**DISD - ALBERT C. BLACK ELEMENTARY SCHOOL**

DISD - W.W. BUSHMAN REPLACEMENT ELEMENTARY SCHOOL

ZONING CASE # Z 212-271

**01** SITE PLAN  
1" = 50'-0"

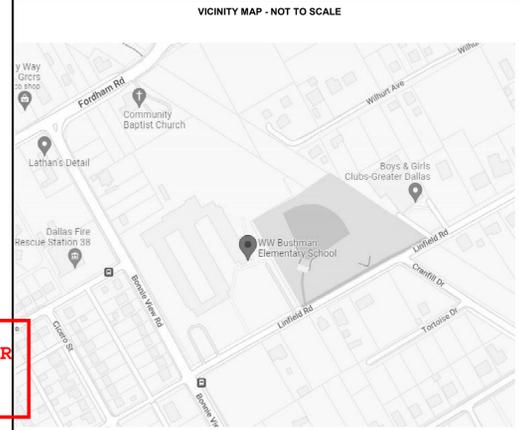
1. REVISE INTERNAL CONNECTION WITH PERPENDICULAR INTERSECTION PER ENGINEERING STAFF COMMENTS.
2. ADD PAVED PEDESTRIAN PATH ALONG CIRCUITOUS DRIVEWAYS AND/OR PEDESTRIAN ROUTES THROUGH THE CAMPUS FROM ALL ACCESS POINTS. (ACCESS ROUTES SHOULD BE DESIGNED IN A MANNER THAT WILL ALLOW PEDESTRIANS TO ACCESS BUILDING ENTRIES WITHOUT THE NEED TO CROSS INTERNAL VEHICULAR TRAFFIC/QUEUE LINES.)
3. NOTE: 5'-0" WIDE SIDEWALK IS MINIMUM REQUIRED FOR ADA COMPLIANCE; HOWEVER, STAFF RECOMMENDS MINIMUM 6'-0" WIDE SIDEWALKS AT SCHOOLS.
4. OTHER PEDESTRIAN AMENITIES SUCH AS BENCHES, TRASH CANS, AND PEDESTRIAN SCALE LIGHTING ARE RECOMMENDED AT REGULAR INTERVALS ALONG STREET FRONTAGES, HOWEVER, THESE ITEMS ARE NOT CURRENTLY REQUIRED BY CODE.

**Staff comment:**  
REVISE PLAN TO REMOVE VISIBILITY OBSTRUCTIONS.

**Staff comment:**  
ENSURE THAT SUP SITE PLAN AND TMP ARE CONSISTENT BEFORE SUBMITTING REVISIONS.

**Staff comment:**  
SHOW 20' X 20' VISIBILITY TRIANGLES AT ALL POINTS OF INGRESS/EGRESS, TYP.

**Staff recommended language:**  
MINIMUM 6'-0" WIDE SIDEWALK w/ MINIMUM 5'-0" WIDE BUFFER MUST BE PROVIDED ALONG THE ENTIRE LENGTH OF ALL STREET FRONTAGES, TYP.

**Staff comment:**  
NOTE: CONSIDER ADDING SIDEWALK LANGUAGE AS AN SUP CONDITION TO COMMUNICATE INTENT THAT SIDEWALKS AND BUFFER ARE TO BE PROVIDED AS NOTED ABOVE (i.e. TO ELIMINATE THE POSSIBILITY OF A SIDEWALK WAIVER BEING OBTAINED FOR THE PROPERTY).

**Staff comment:**  
EXTEND THROAT OF DRIVEWAY TO AVOID ABRUPT TURN.

**Staff comment:**  
TABLE HAS INCORRECT DATA. CONFIRM THE MATH AND CORRECT THE DATA.
